Spokane River Stewardship Partners

Subject: Comments on Spokane River Draft DO TMDL

The Spokane River Stewardship Partners (SRSP) have the following comments on the Spokane River and Lake Spokane Dissolved Oxygen Total Maximum Daily Load, Draft Water Quality Improvement Report (Draft DO TMDL) that was issued on September 15, 2009:

Figure 1. Water quality model results for TMDL Alternatives 1, 2, and 3 Showing Dissolved Oxygen in Lake Spokane

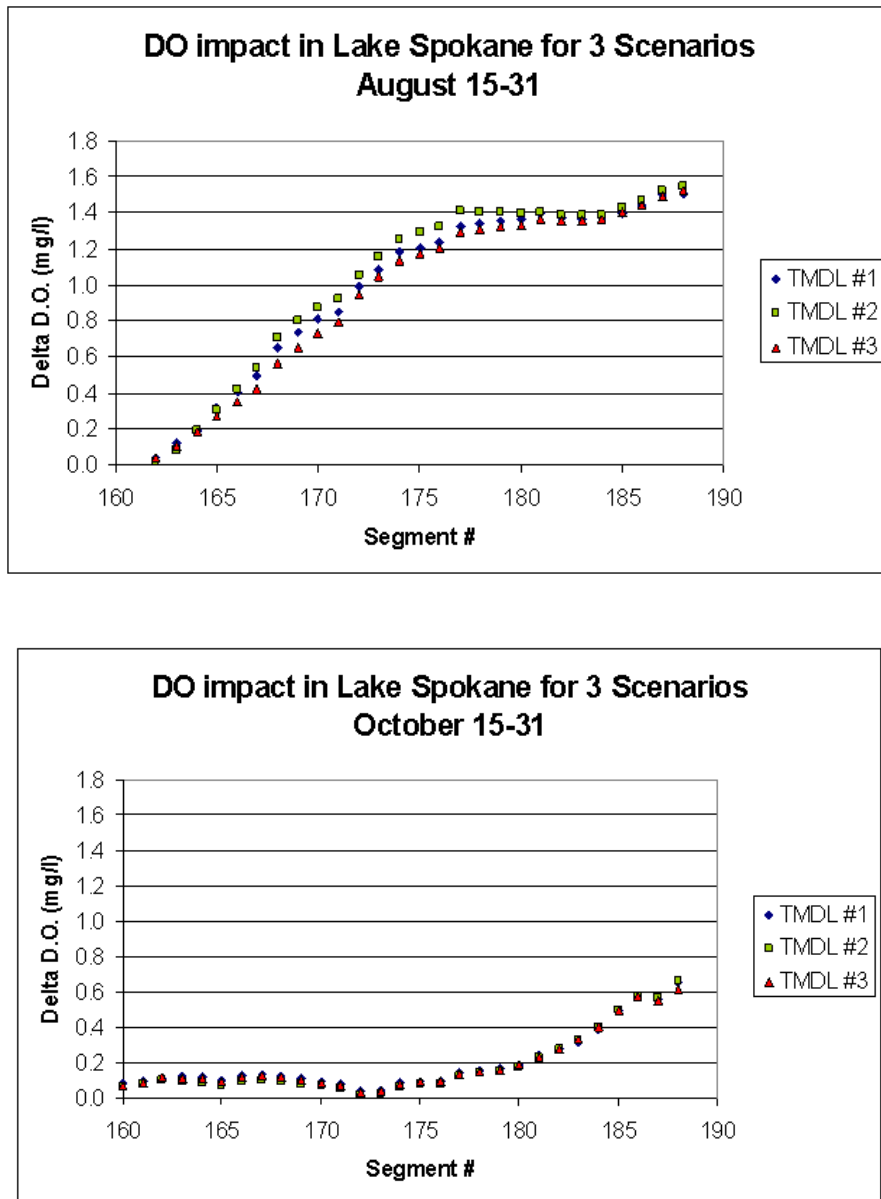
In order to evaluate dissolved oxygen concentrations in Lake Spokane and the Spokane River, three TMDL alternative scenarios were simulated using the CE-QUAL-W2 water quality model. Results of the TMDL alternative model simulations were presented by Ben Cope, USEPA Region 10, on June 25, 2009, as show in Figure 1. EPA examined the model results for differences in dissolved oxygen concentrations between a No Source scenario and the TMDL alternative scenarios along the reservoir (segments) for two periods. Figure 1 below is EPA's representation of the two periods analyzed: August 15-31 and October 15-31, 2001, the year of the baseline model.

The differences in dissolved oxygen between the TMDL alternatives are likely within the error band or the range of accuracy of the CE-QUAL-W2 model. Although the model may be able to predict dissolved oxygen to within some range of the actual value (potentially +/- 0.2 mg/l), the average difference in the TMDL alternatives is less than +/- 0.05 mg/l. While the model is able to predict small differences, these are not results that will be measureable in actual monitoring of dissolved oxygen concentrations in Lake Spokane. While the model simulation results do respond to changes in the total phosphorus inputs, the small difference in results indicate that all TMDL scenarios are virtually the same in terms of the impacts to water quality.
